ASSESSMENT REPORT

Hunter Valley Operations South Section 75W Modification (MP 06_0261 MOD 1)

Figure 2: Proposed boundary amendment and current and proposed Lake James dam footprint

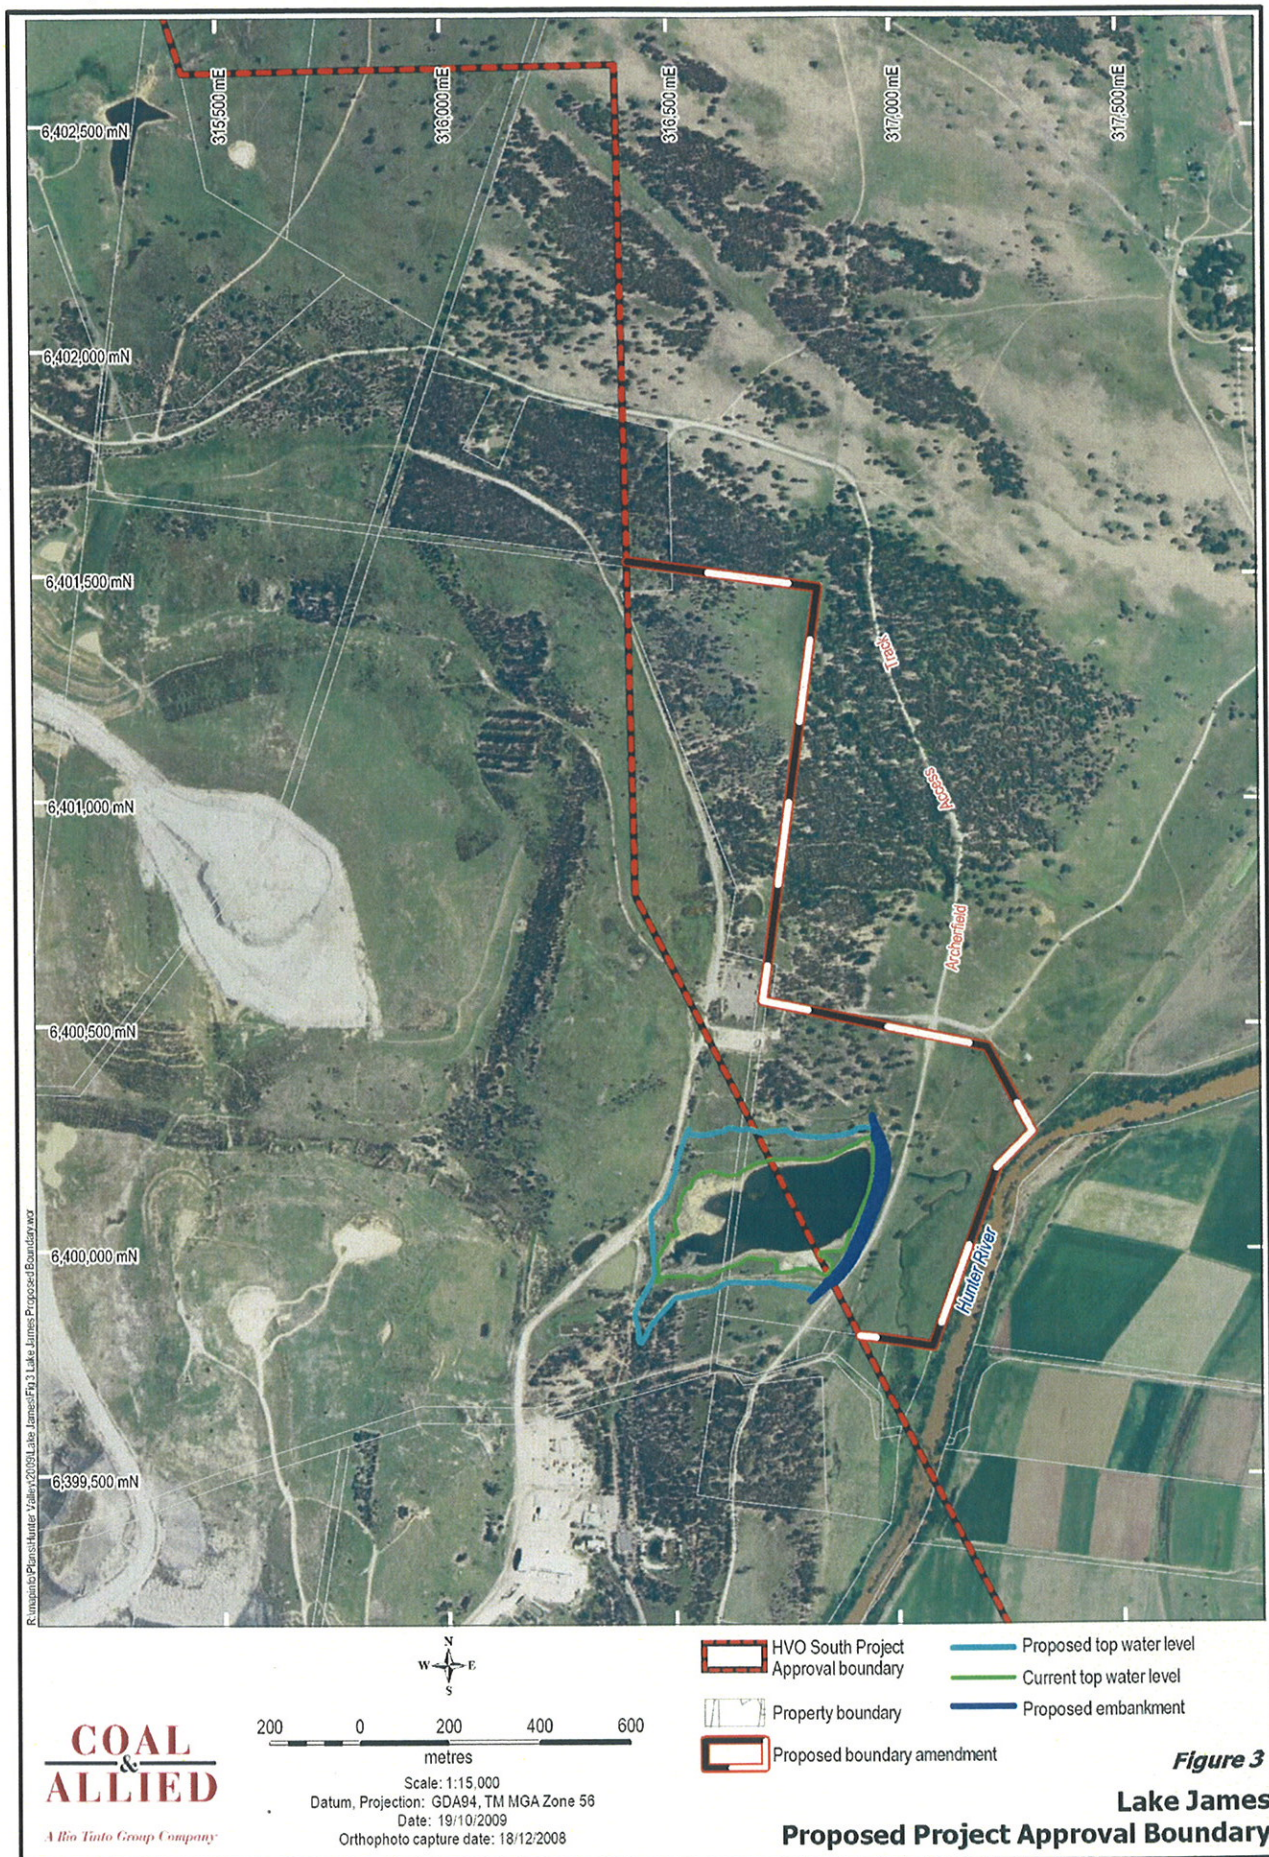
The project approval boundary as shown in the existing project approval bisects Lake James. In order for the proposed modification to be approved, the current project approval boundary needs to be extended to incorporate the Lake's extended footprint and all associated infrastructure (see Figure 2).

Figure 3: Lake James additional storage capacity design

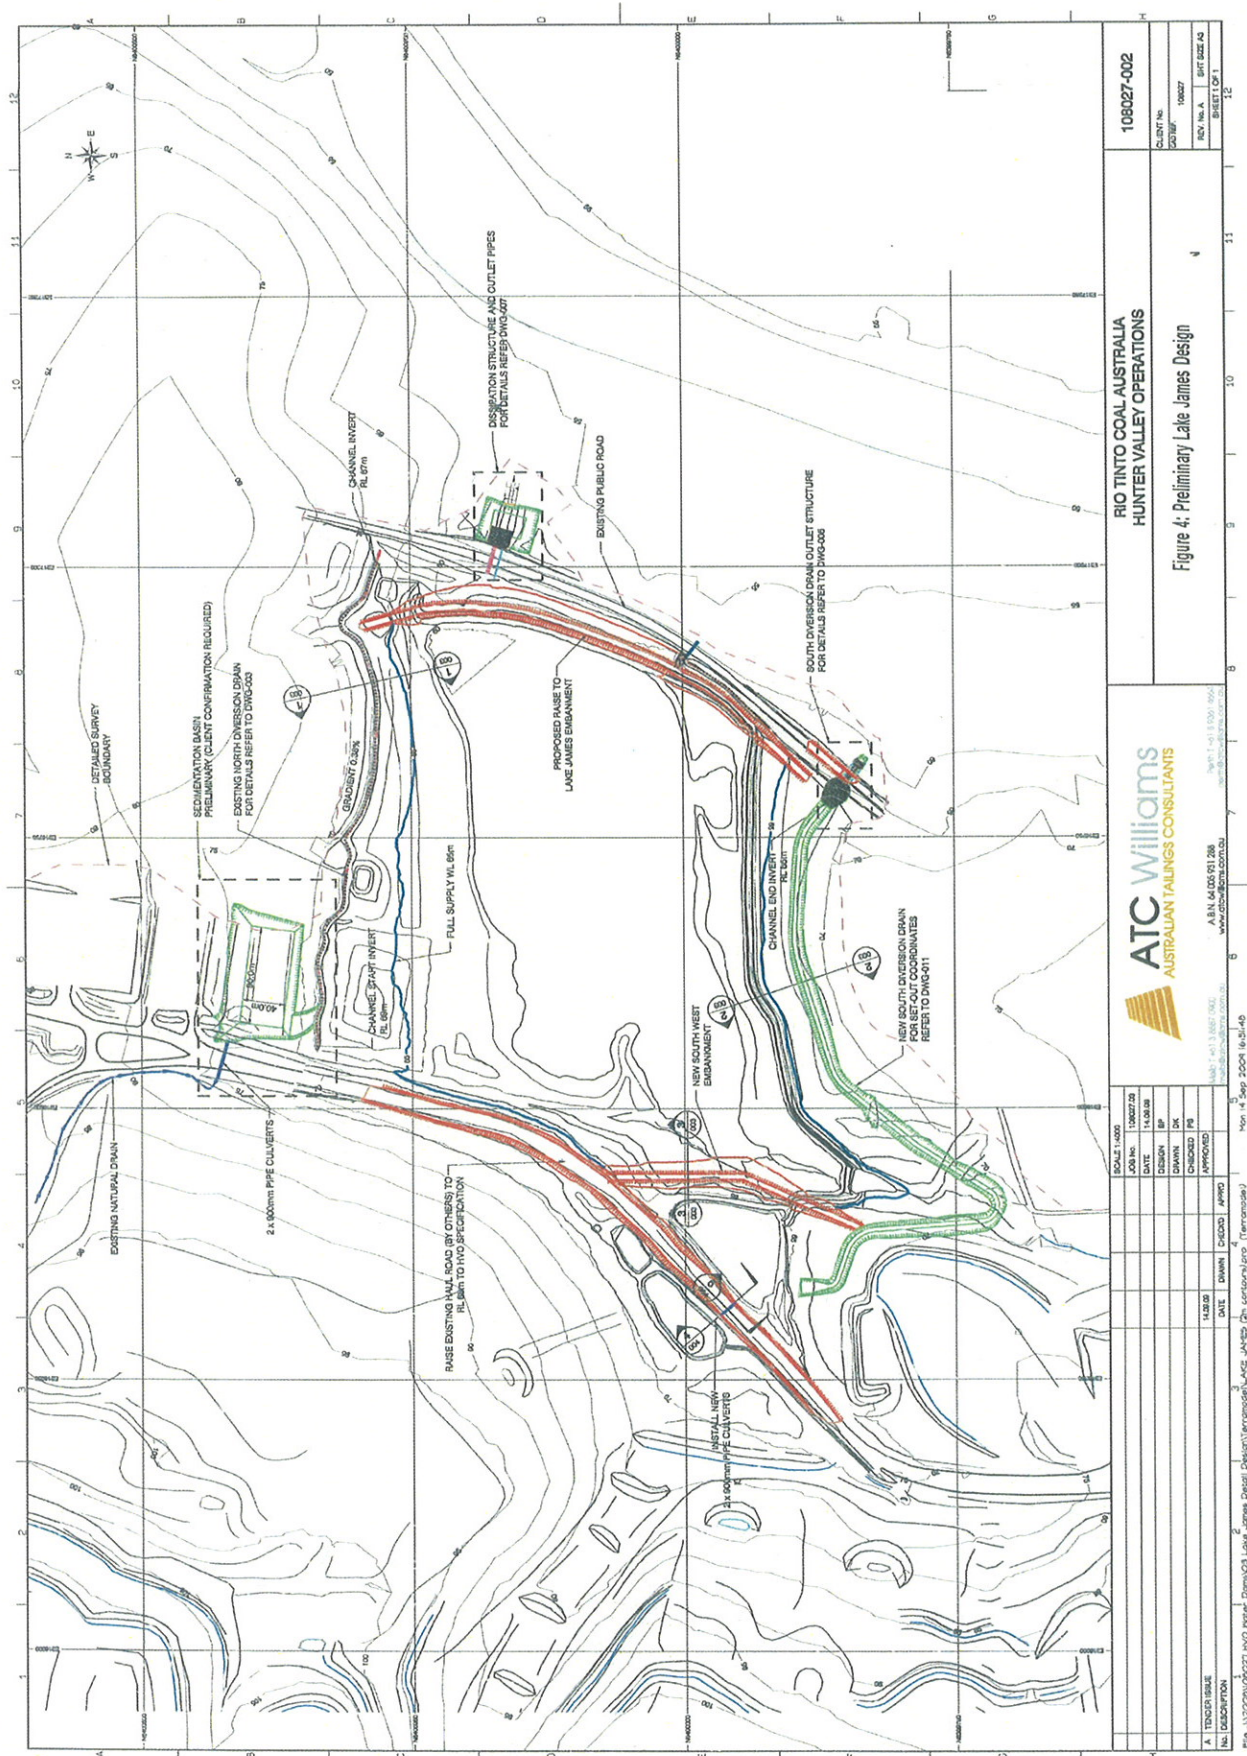
- increasing the existing footprint of the dam from approximately 10 hectares (ha) to approximately 20 ha (see Figure 3)
- an embankment raise of approximately 2.5 metres (m) in height and an increase in the length of the embankment by approximately 30 m;
- the excavation of a 4 ML dissipater dam (approximately 40 m x 50 m), to the east of Lake James, that would provide for secondary containment, testing capacity and control of discharge; as well as additional buffering capacity in the event of a dam leak or flood event;
- the realignment of the southern clean water diversion further upslope, as the existing diversion would be absorbed into the increased footprint; and
- construction of an 8.5 ML sediment dam (approximately 55 m x 50 m) to control water entering the existing northern clean water diversion.
